STATE OF IDAHO
DEPARTMENT OF WATER RESOURCES
BENEFICIAL USE FIELD REPORT

5/23/96
REVISION

Permit No. 67-07809

TO: Western Region
FROM: Brenda Chapman
DATE: November 22, 1993
RE: Returned Exam / Permit 67-07809
Wayne Cada

SYSTEM DESCRIPTION
ATTACHMENT TO FIELD EXAM FORM

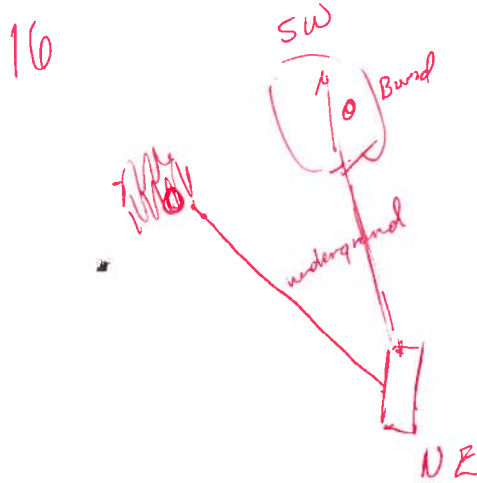
I am returning the field exam on the above referenced permit to have the points of diversion and places of use in Section 16 verified and corrected. The drawing attachment and map are not in agreement.

Schematic shows correct layout
except legals - see logs for
correct legals

System #1 2 springs, 1 on near QQQQ so describe
as 2 p/d in S¹/₂SESW.

P/O
= SESW

System #3 6 springs, all within W¹/₂ NENW, water
collected (via pipes from springs) in 2
headboxes then piped to trough in
SWNE. Trough clearly visible from road.

= NENW
